**DESIGN REVIEW BOARD CONCEPT REVIEW**

**Design Review Board Case # 2022-0001  
Carlyle Block C Rooftop Amendment – 1940 Duke Street**

Figure 1. Bird's Eye View of Penthouse Addition

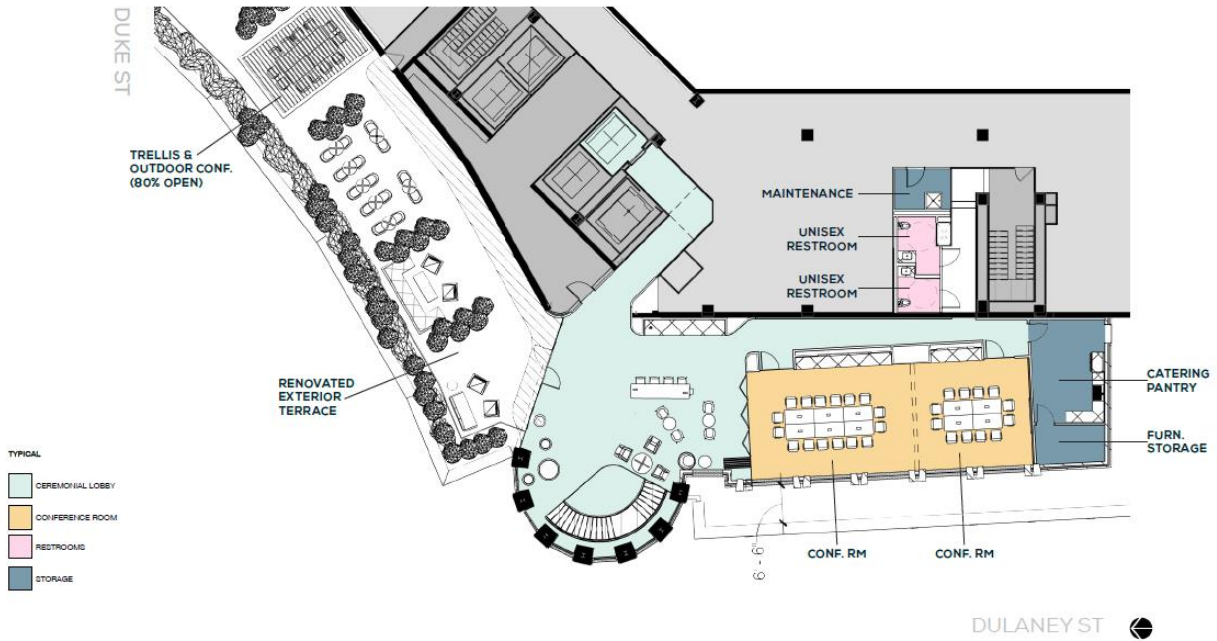
- Staff does not support the projecting bulkhead (with the red band) currently shown running along the Dulaney side of the boardroom and wrapping around the south end of it. The

proposed red roof form of the board room and the red architectural feature on the left (east) side of the tower have no relationship to the existing building and are completely out of place visually. Staff recommends removing these items from the design and provide a design for the top of the new boardroom wall similar to the existing roof parapet/cornice form of the floor below. With the removal of red roof form, staff also recommends extending the height of the board room windows.

- Staff recommends adding another double pier and windows on the Dulaney side of the board room and three more double piers and windows symmetrically around the corner on the south side of the board room, to wrap the west facing language around to the intersection of the south wall with the existing pentouse, with glass infill between the piers to match the current proposal facing Dulaney. As the interior of the south end of the structure is used for storage, the use of spandrel glass in these openings would be acceptable.

- The change to the existing tower eradicates the original open-work tower top design, which is the most iconic part of the building and the Carlyle gateway, and the architectural relation to the main office building canopy on the first floor. Staff strongly recommends limiting any proposed enclosure of the existing tower openings to deeply recessed glass and leaving the detailed soffit, cast stone sills and all other existing trim exposed. Staff does not take exception to the solid enclosure of the circular tower roof top.

Figure 4. View from Duke Street Overpass Heading East

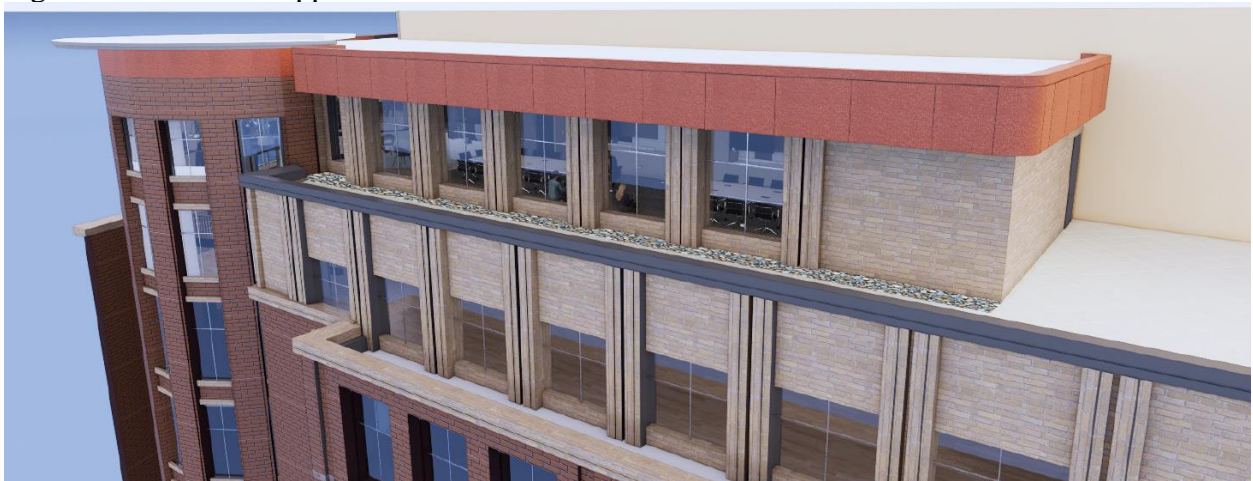
The rooftop addition will not be very visible from the pedestrian realm on Dulaney Street but will however be very visible from nearby areas. The Carlyle neighborhood is at geographic low point compared to the land to the north, which is especially elevated around the George Washington Masonic Memorial. From the memorial and other nearby areas, the Applicant's proposal rooftop addition will be clearly in viewable. Therefore, it is especially important the addition tie into the existing building. The visual importance of the architectural expression of this (admittedly small) proposed addition is nowhere clearer than in the view one sees when descending from the Duke Street overpass eastbound (see below). From that vantage point, the addition as currently clad introduces a massing and expression that clash with the existing stepped massing and language.
